Proposed Project Modifications

V41

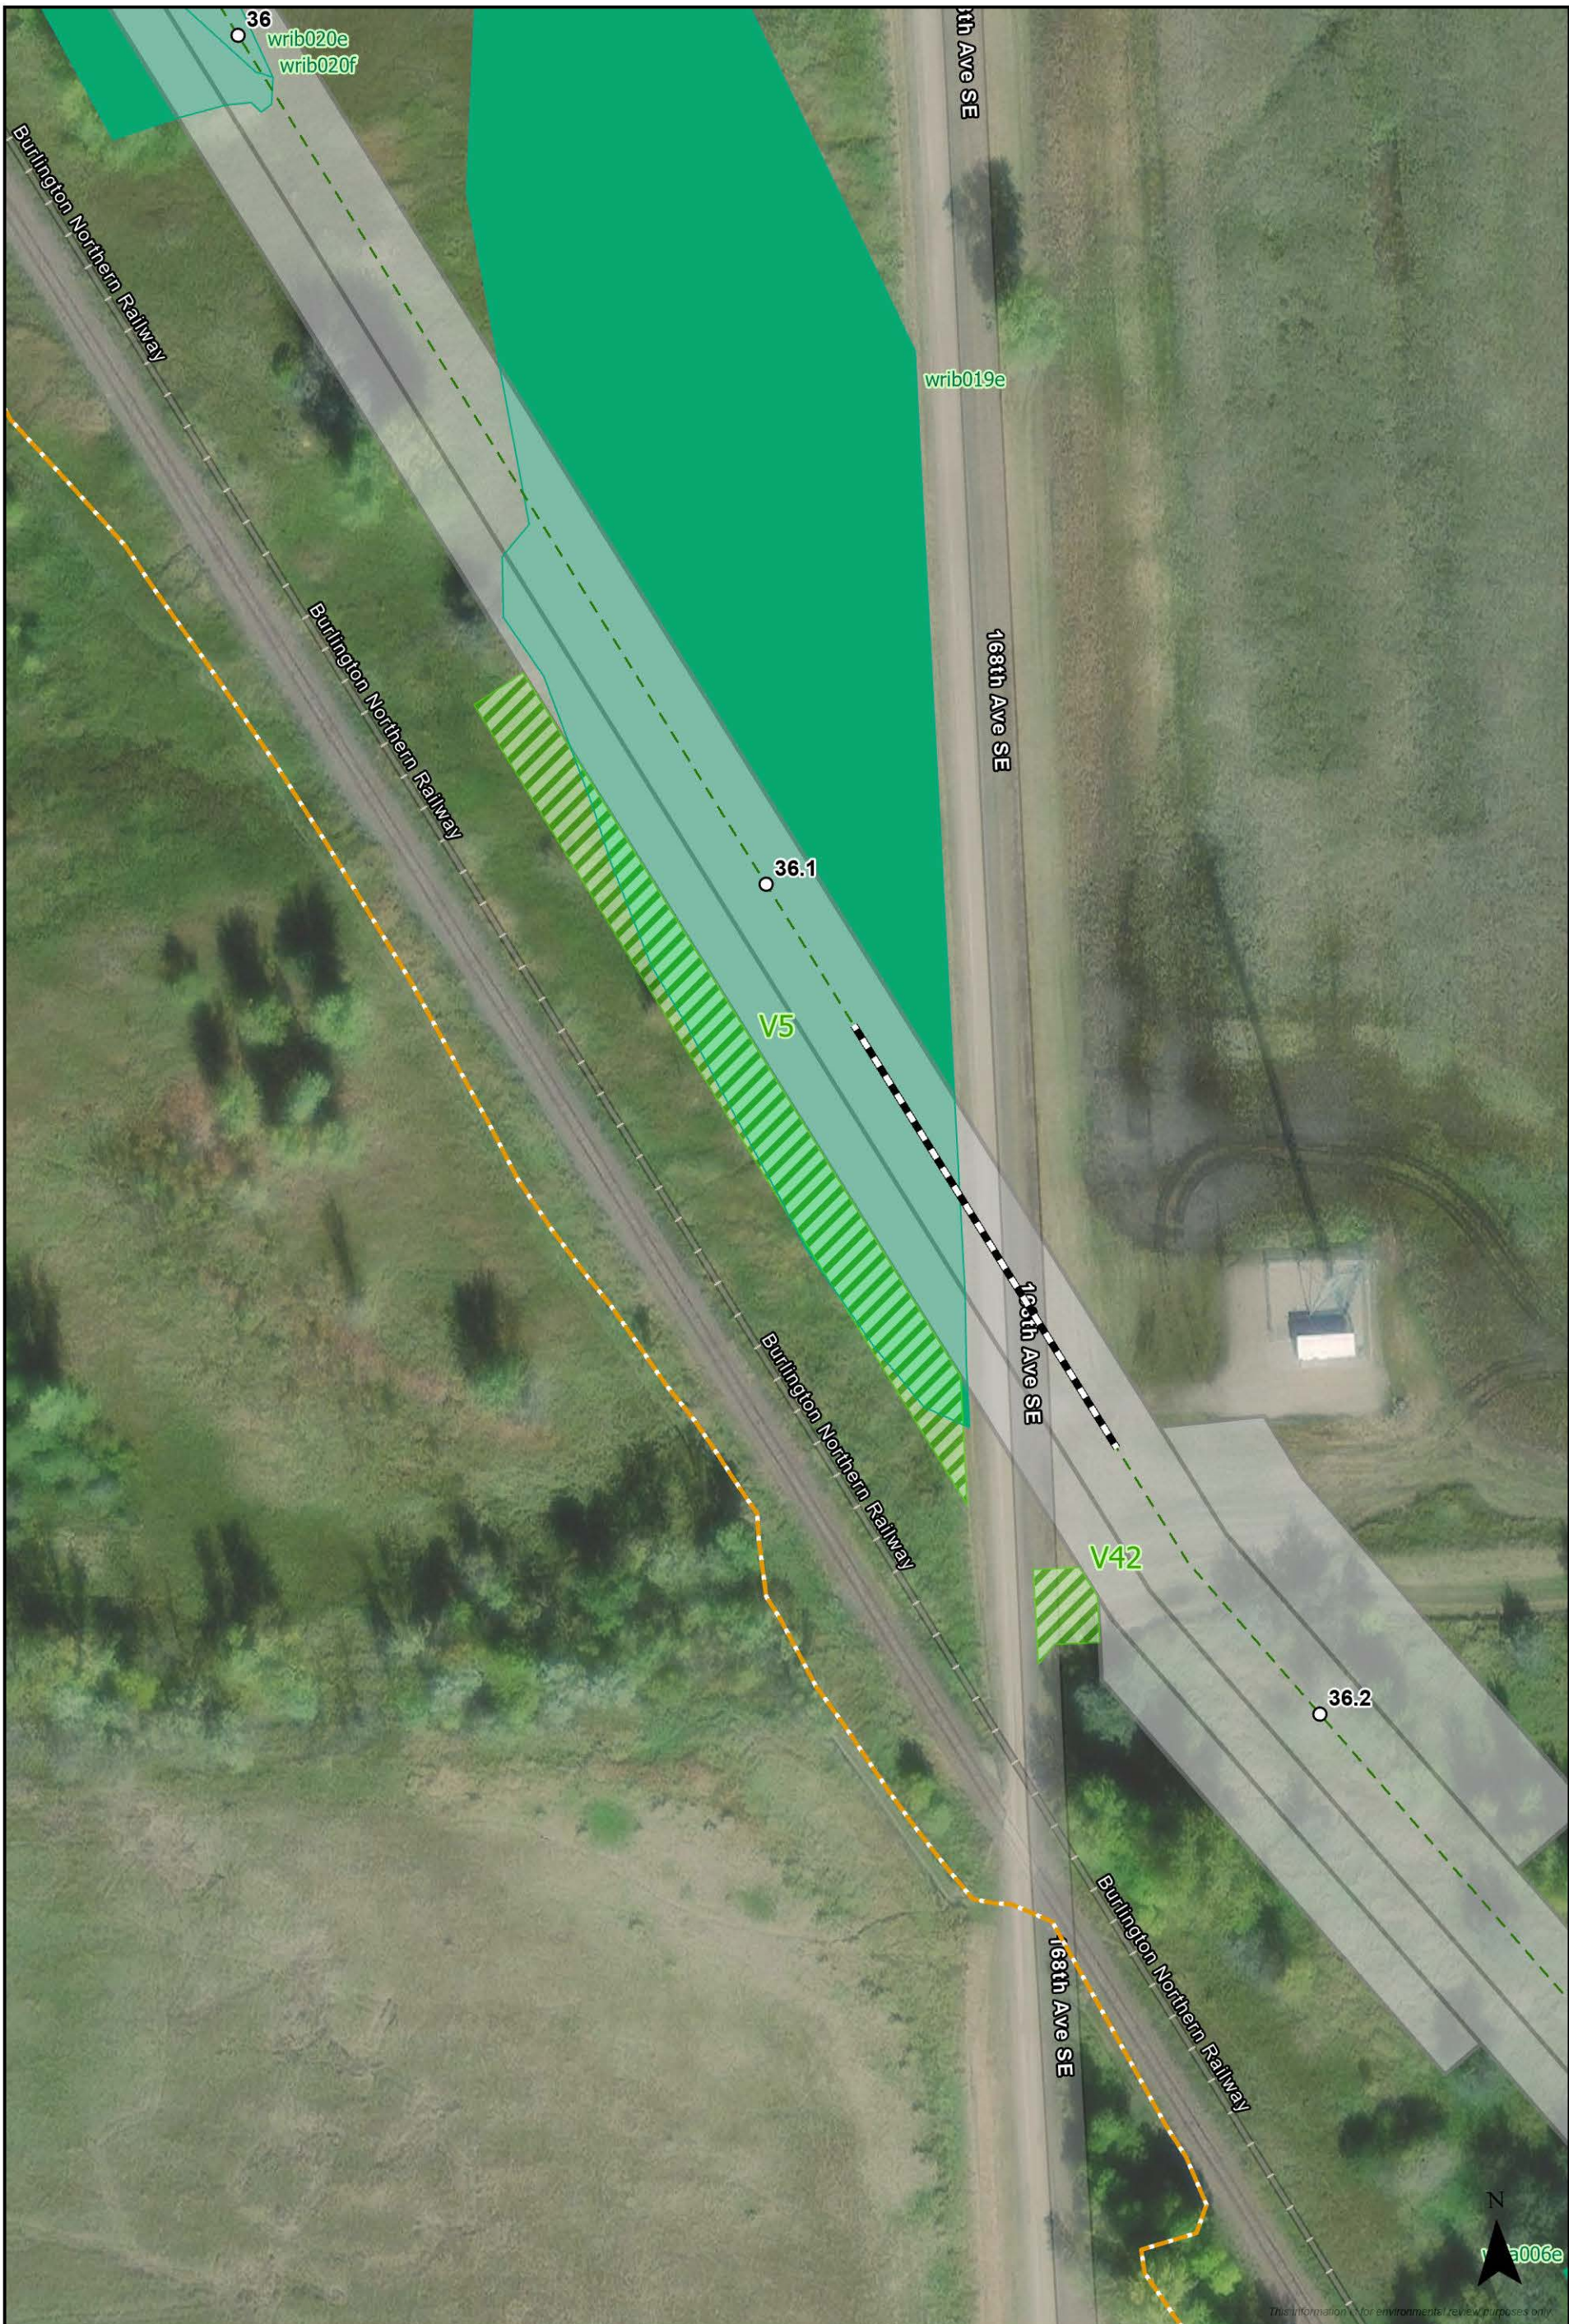
TEMP Workspace Added	North Country Trail - Public
Milepost	No Change
Centerline	Surveyed Wetland
Bore Location

V5 and V42

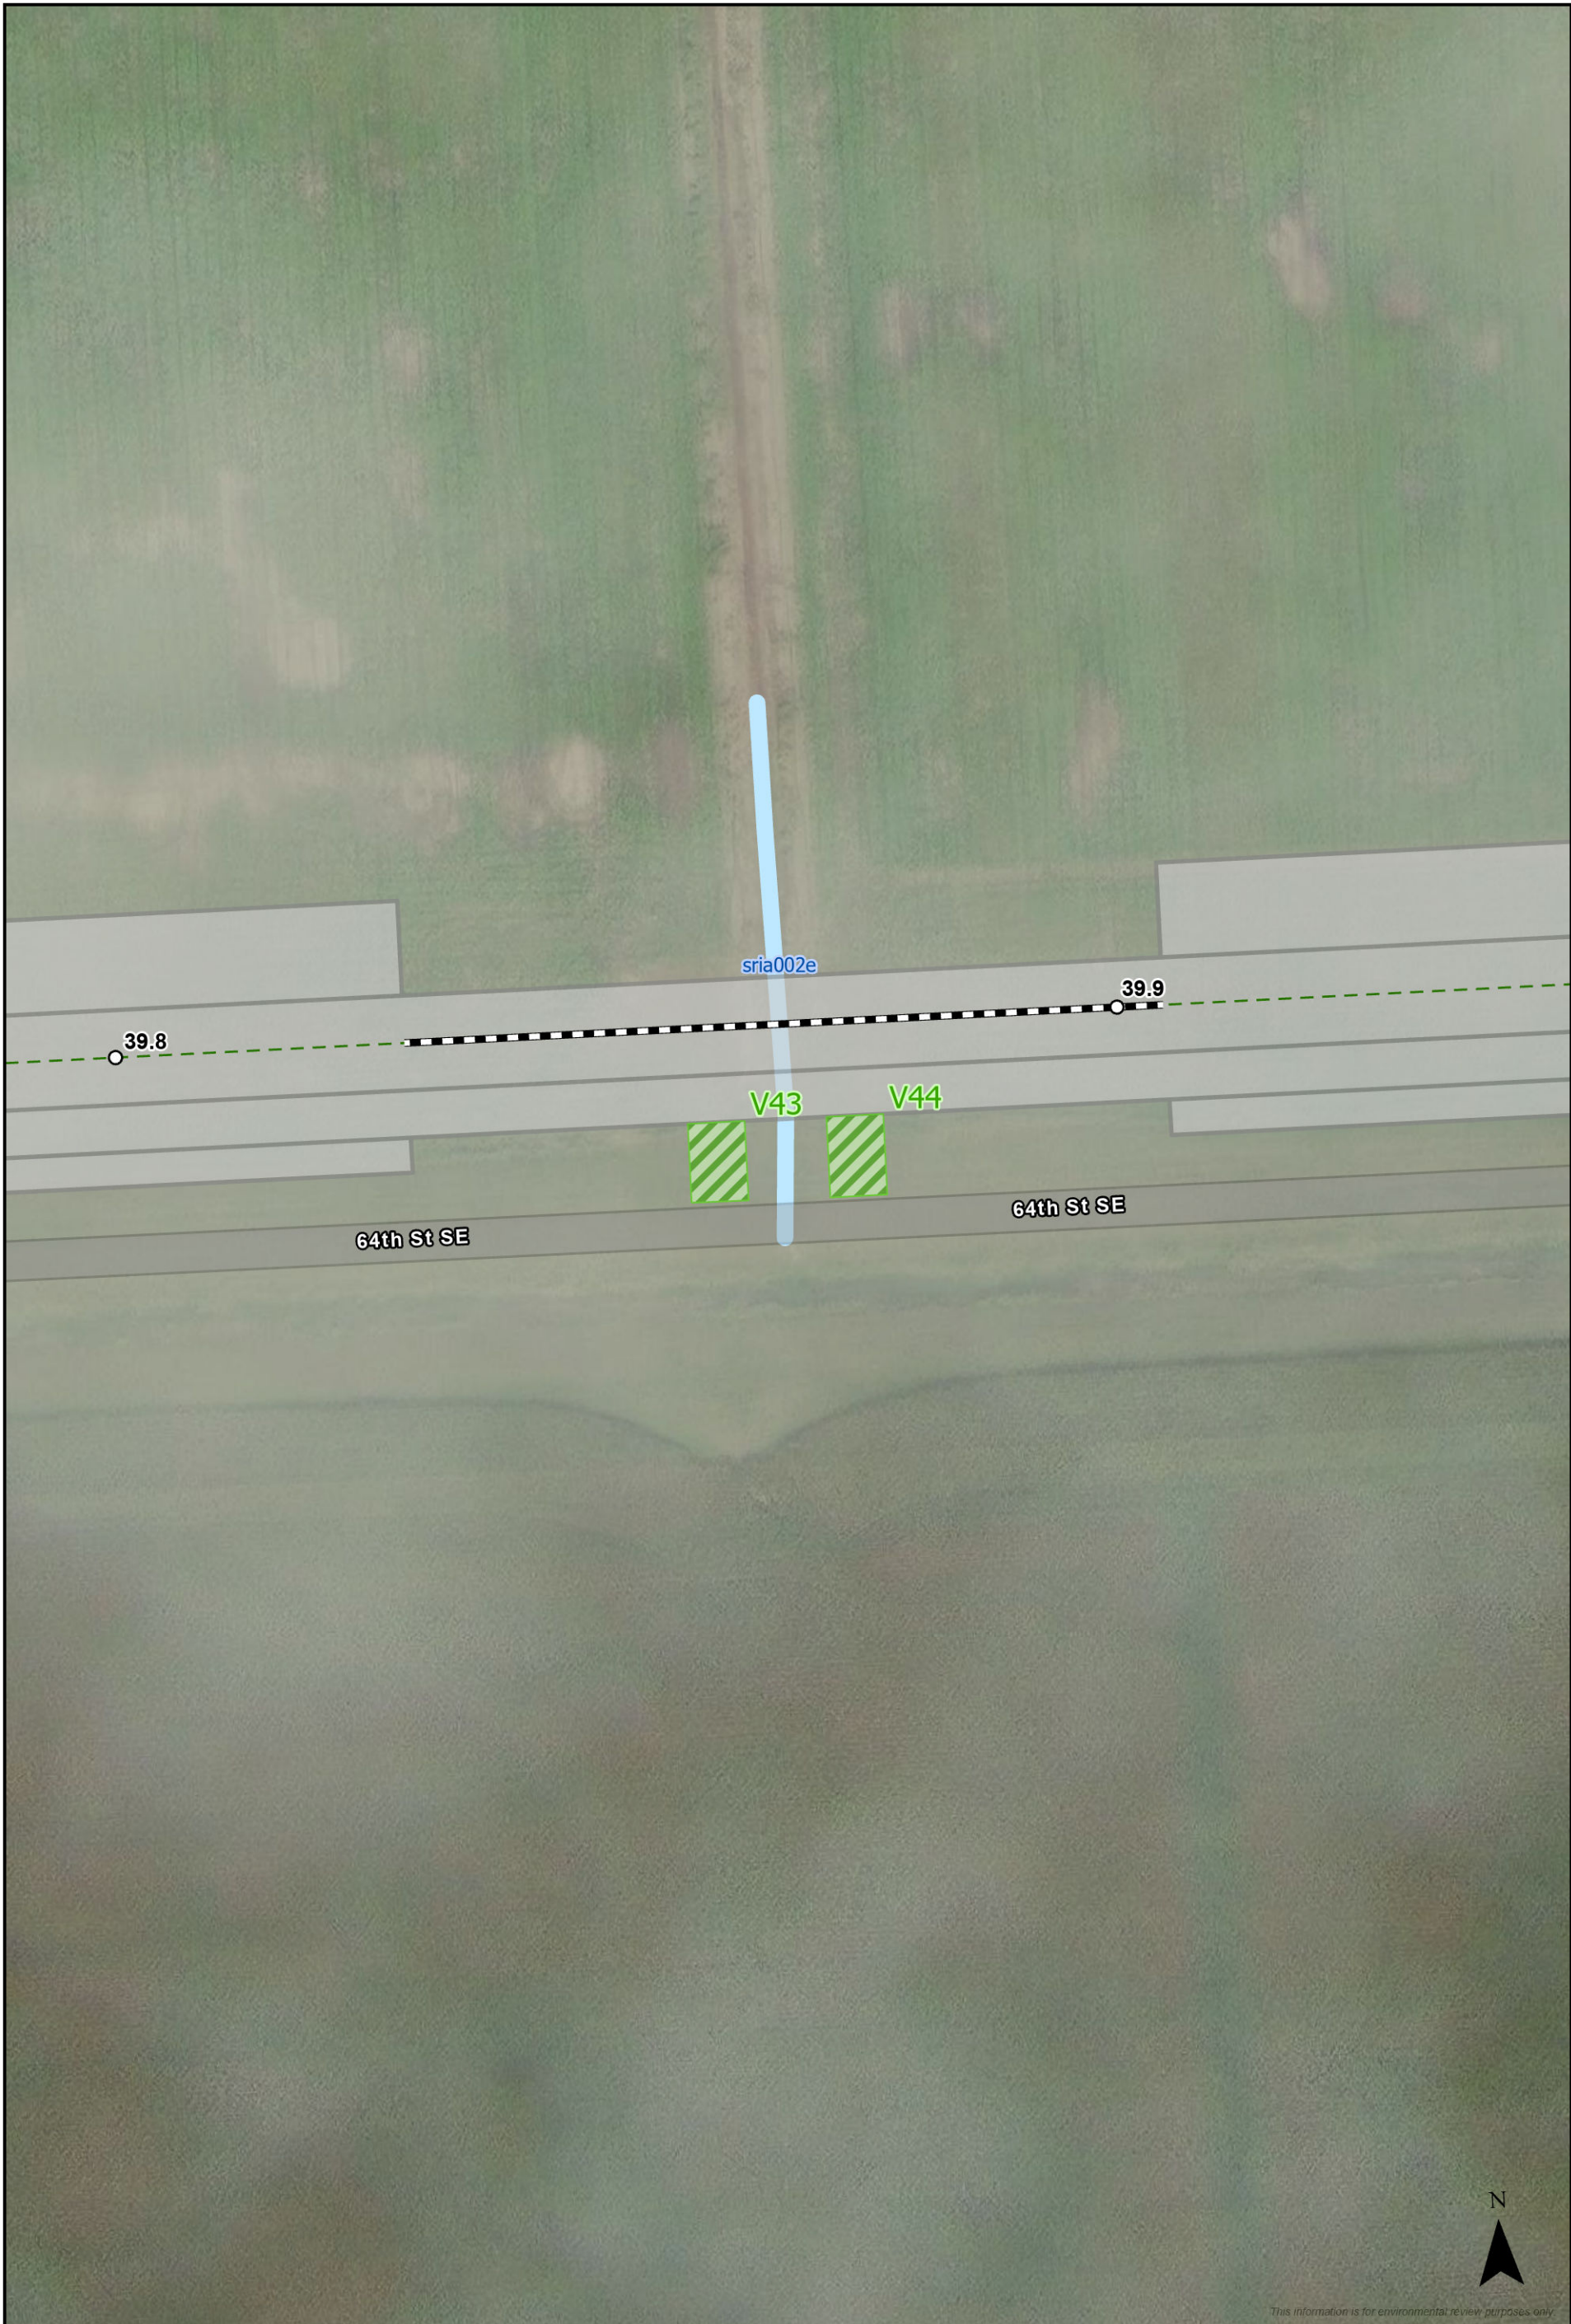
TEMP Workspace Added	North Country Trail - Public
Milepost	Surveyed Wetland
Centerline	No Change
Bore Location

V57

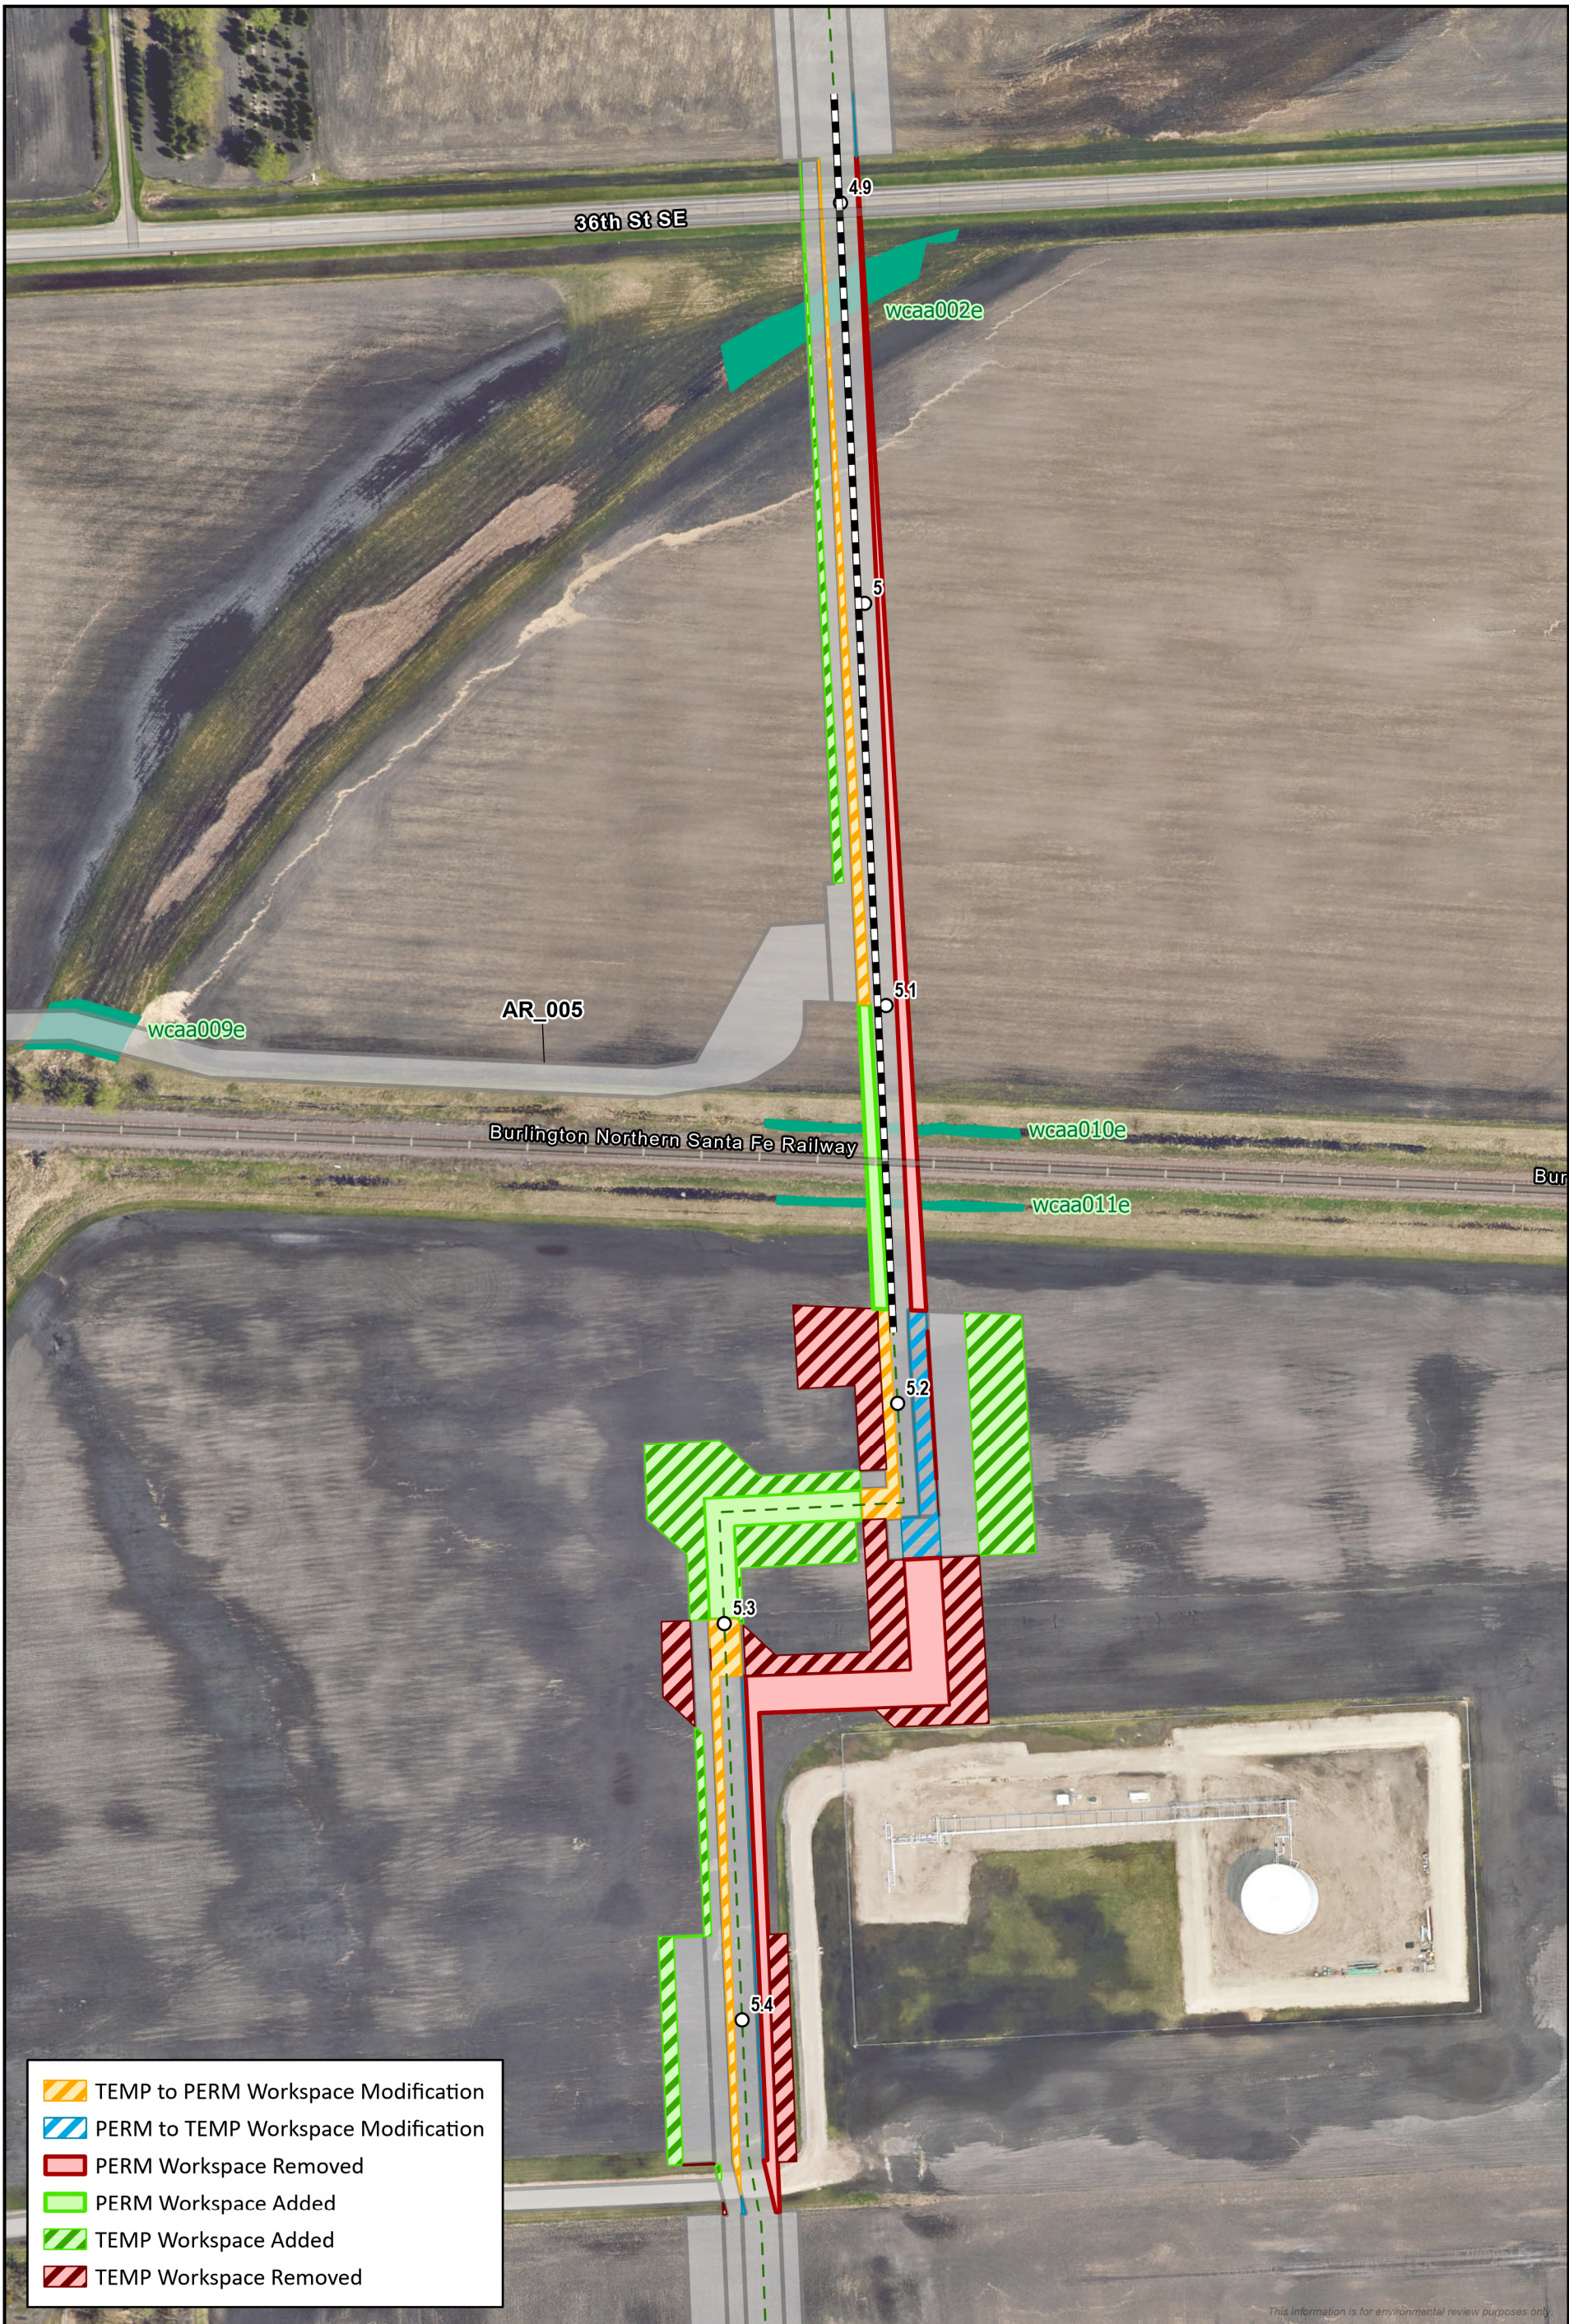
- PERM Workspace Added
- PERM Workspace Removed
- PERM to TEMP Workspace Modification
- TEMP Workspace Added
- TEMP Workspace Removed
- TEMP to PERM Workspace Modification
